PLAT COMMITTEE

| Case Number: | 2024-PLT-050 |
| Request: | Approval of a Subdivision Plat to be known as Victory Manor, subdividing 8.533 acres into 50 lots. |

Traffic Plan

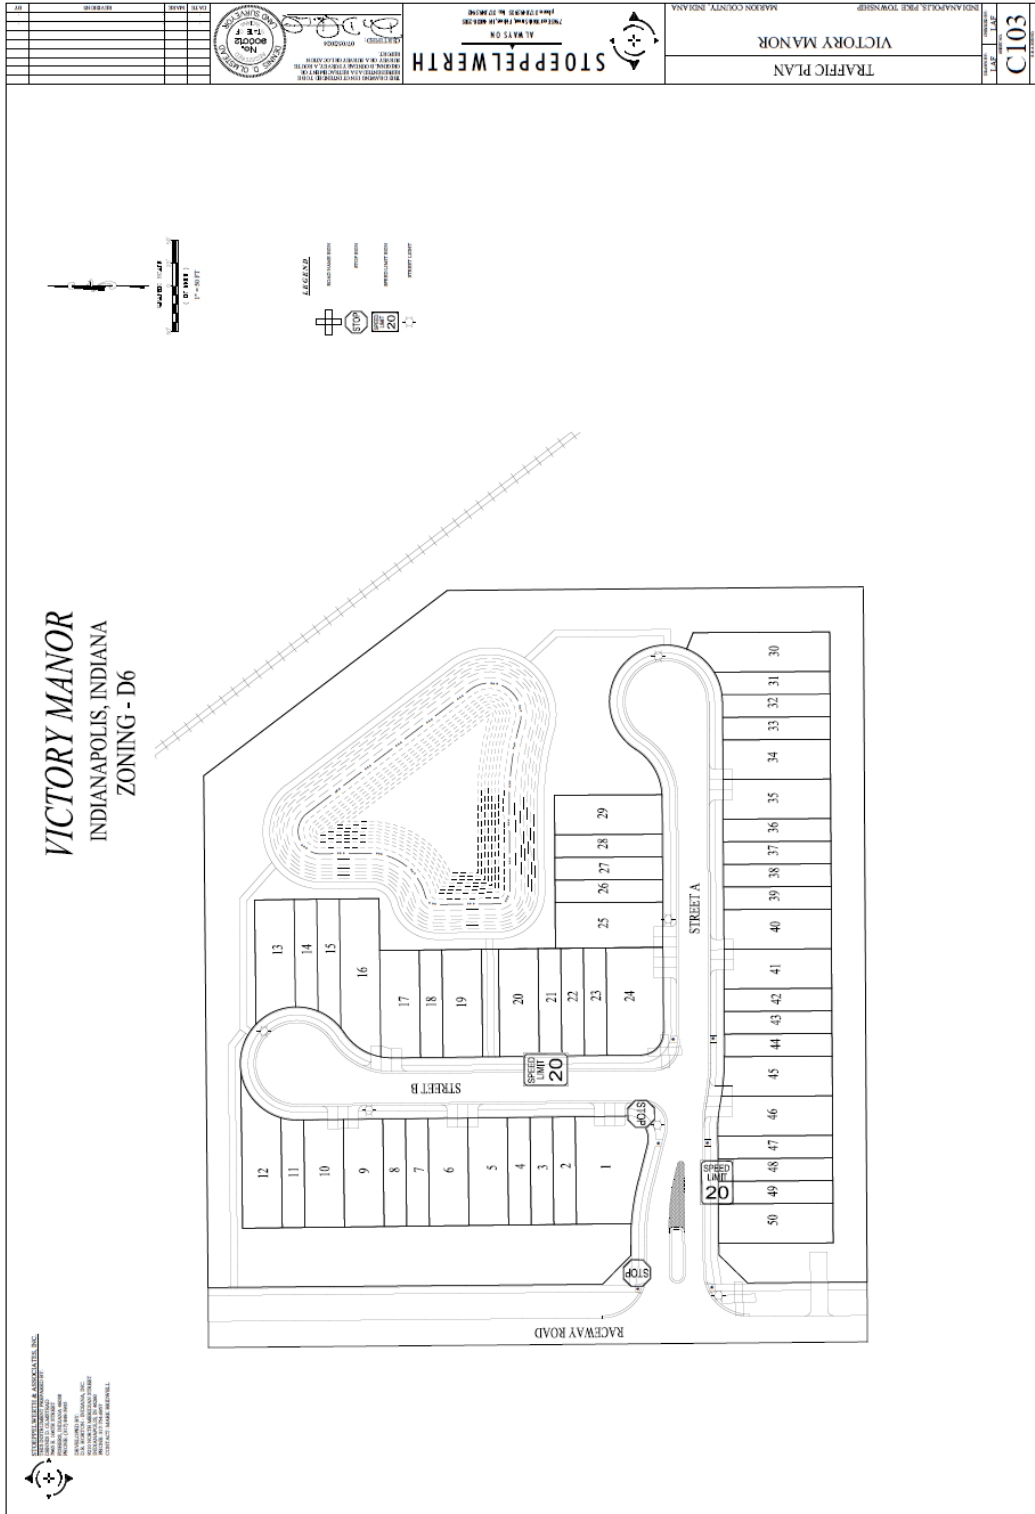
| <p>741-203.D – Traffic Control Plan</p> <ul style="list-style-type: none"> • Traffic control street signs and devices. • Traffic calming devices. • Bicycle facilities. • Sidewalks and pedestrian facilities. • Transit facilities, such as bus stops pads or shelter. • Street lighting. | <p>Satisfied</p> |
